TO: BJ Jones, CEO, BPCA, Martha Gallo, Interim-Chairperson, BPCA,
(one of two local resident Governor appointees)

FROM: Battery Park City Neighborhood Association

DATE: July 8, 2022

Detailed Response on 1.0 Project Justification

Elevation of South Battery Park City

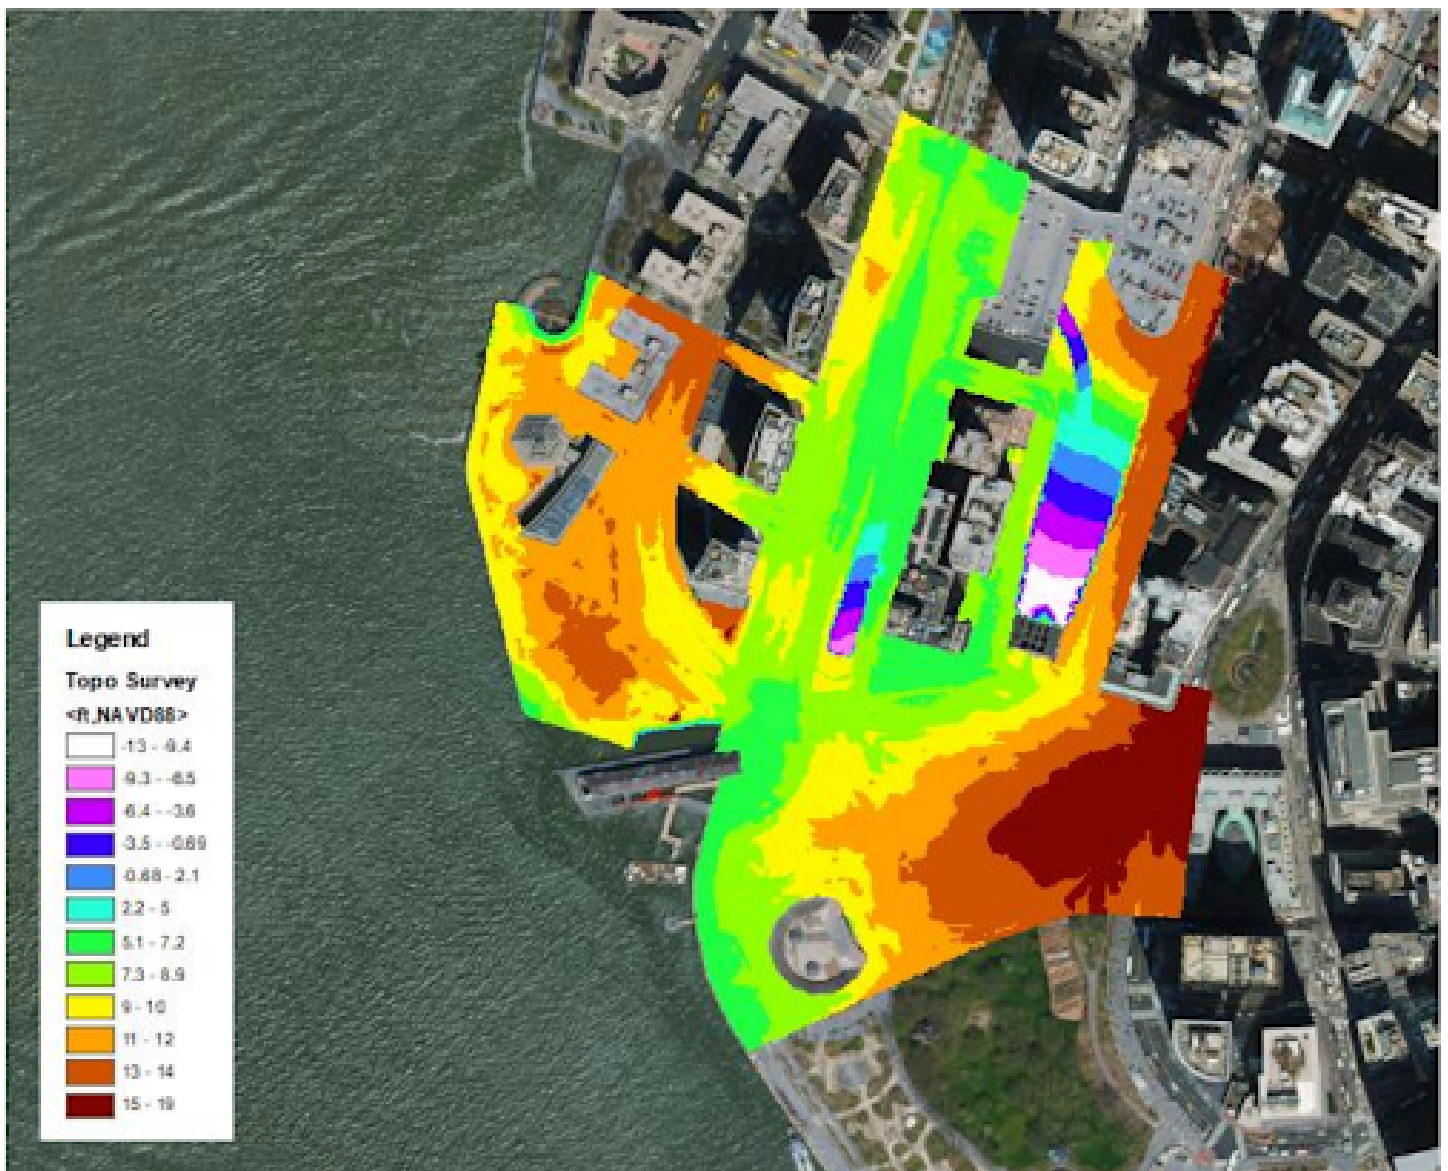
The below topography chart (page 5) shows that the Jewish Museum's height is 11 to 12 feet. Hence in using the latest FEMA model for storm surge, the Jewish Museum is already at an elevation to withstand a 100 year storm.

Figure 2-16 MIKE 21 HD FM Model: Calibration with 1984 Nor’easter at NOAA The Battery Station

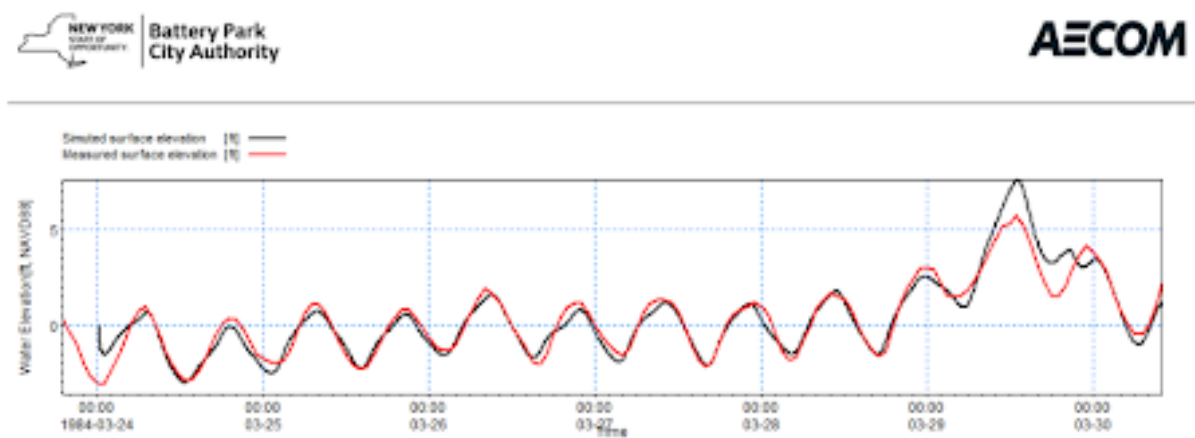
AECOM uses two models for regional- and local-scale storm surge: ADCIRC and MIKE 21, respectively. MIKE 21 outputs were ultimately used to determine the storm surge levels in the project site. After being calibrated against the 1984 Nor’easter, both models were only validated against a single storm - Sandy. We believe this amount of validation is grossly insufficient, especially for such low frequency events, such as storms of Sandy’s magnitude. For comparison, the city’s independent analysis validated their model against all 30 Extratropical storms on record that have hit this region. In particular, the AECOM model performs poorly at fitting peak storm surges, which is precisely what we would expect such models to do well. For both the calibration and the validation, MIKE 22 predicts a storm surge 1.66 feet higher than what really happened, as shown in the figures below (page 18 and 21 in the report, respectively):

This overprediction of peaks is something that even AECOM admits. From page 15: *“It should be noted that although the peak water levels at the tidal stations during the 1984 Nor’easter are overpredicted, the time series of the simulated water levels are identical to the modeled water levels reported in FEMA’s calibration and validation of the ADCIRC model (RAMPP, Region II Storm Surge Project – Model Calibration and Validation, 2014). Generally, given the close comparisons between the study modeling and the RAMPP modeling for FEMA, and that FEMA has used these results previously where rigorous calibration and validation was performed, either set of data would be suitable for application to this study without further adjustment.”*

The BPCNA and scientists in the community reject this line of reasoning since, as was shown above, the FEMA model they compare against was itself not properly validated and it overestimated storm peak surges. In page 20 AECOM notes: *“The peak difference is similar over-prediction as observed with the ADCIRC model. Overall, given the acceptable mean error and RMSE calculated between the model and measured water levels, the model is considered successfully validated for simulation of Hurricane Sandy and all model inputs have been finalized.”* This line of reasoning is not scientifically and statistically justifiable. The R2 and RMSE (Root Mean Square Error) mainly reflect how well the model fits water levels during normal conditions before the storm hits, which dominate the sample of data points in the graph, thus playing an outsize role on the determination of R2 and RMSE. However, the purpose of this model should be to fit the extremes and not the normal conditions. As we have shown, the model overpredicts the peak storm surges in every instance and thus it is not suitable.

Figure 2-21 Comparison of Field Verified and Modeled Hurricane Sandy flood Extents
 (left) Field Verified Flood Map,
 (right) Flood Map Simulated by MIKE 21 HD FM Model

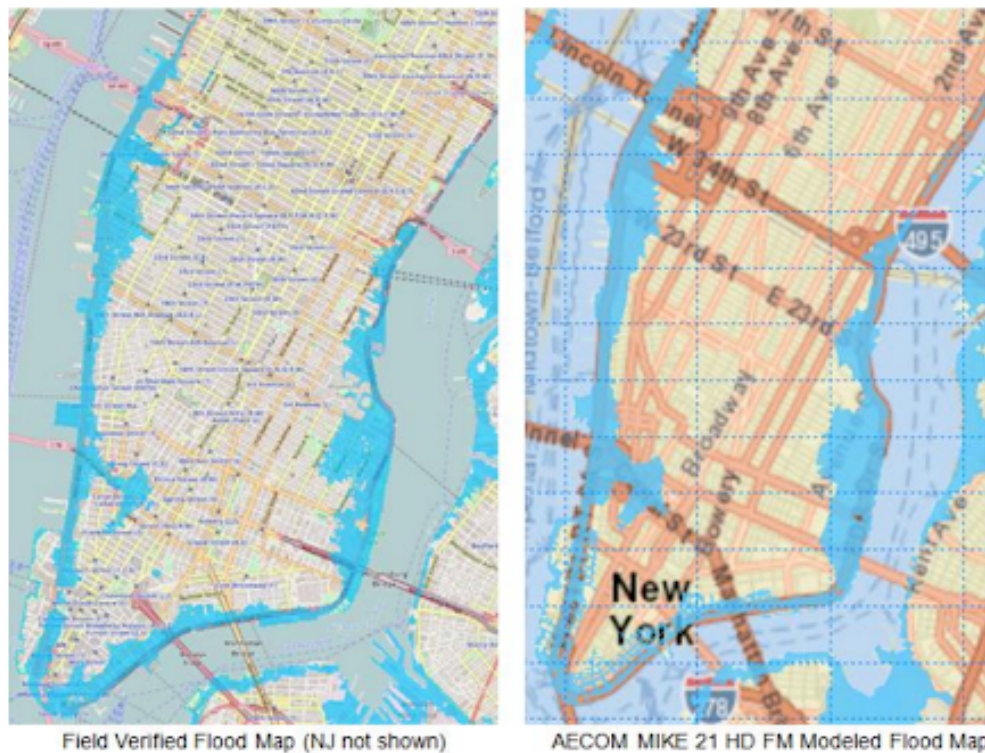
Another example of how AECOM MIKE 21 model overestimates 100-year storm surges is given in page 22. We were not provided with the numbers for the sizes of flooded areas (actual vs. predicted). However, one can discern even by eye that the AECOM model shows larger flood areas in the project site than what happened during Sandy.

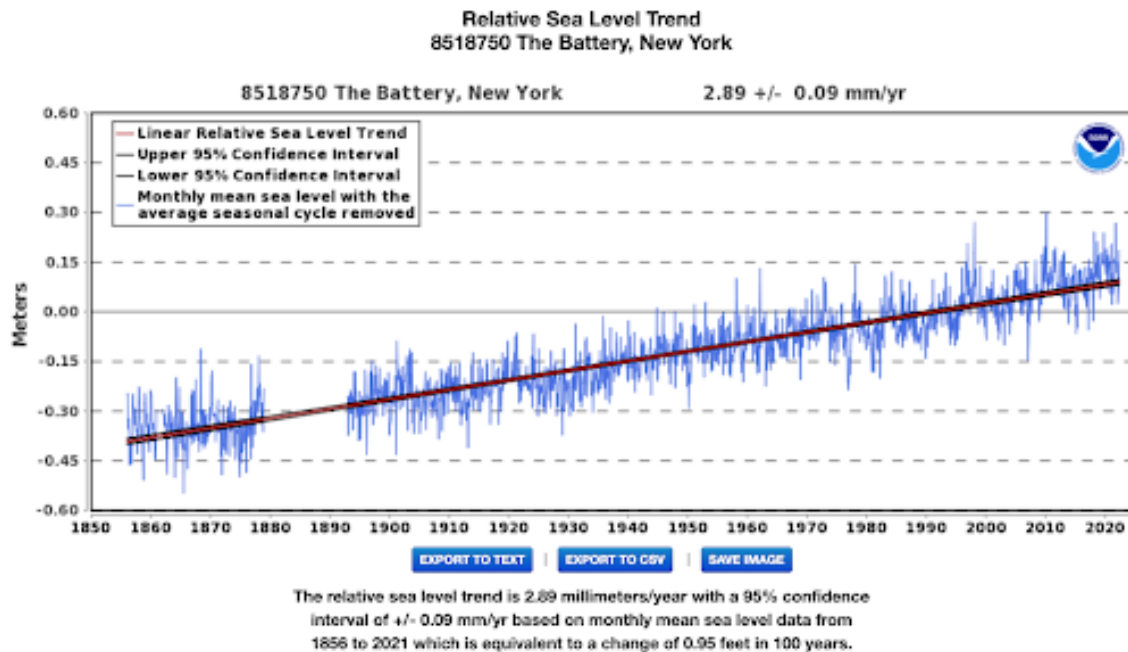
The AECOM report is using the High Projection (90th percentile and the most extreme) sea level rise from the NPCC3 report. Those projections are up to 30 times higher than what we are currently experiencing in sea level rise. Given that we are presently in the decade of the 2020s, we can already reject the 90th percentile projection path that AECOM selected. Here are the current sea level rise trends at [the Battery, as measured by NOAA](#):

The actual measured trend of 2.89 mm/year corresponds to 0.11 inches per year, or ~ 1 inch per decade, which is 10 times smaller than the High Projections (90th percentile) sea level rise for the 2020s that ACOM is using (1 inch vs. 10 inches per decade). If we extend that to the 2050s the measured trend becomes 30 times smaller (1 inch vs. 30 inches per decade). Even allowing for some acceleration in the future rates of sea level rise, there is no natural process that would result in such sudden rate increases.
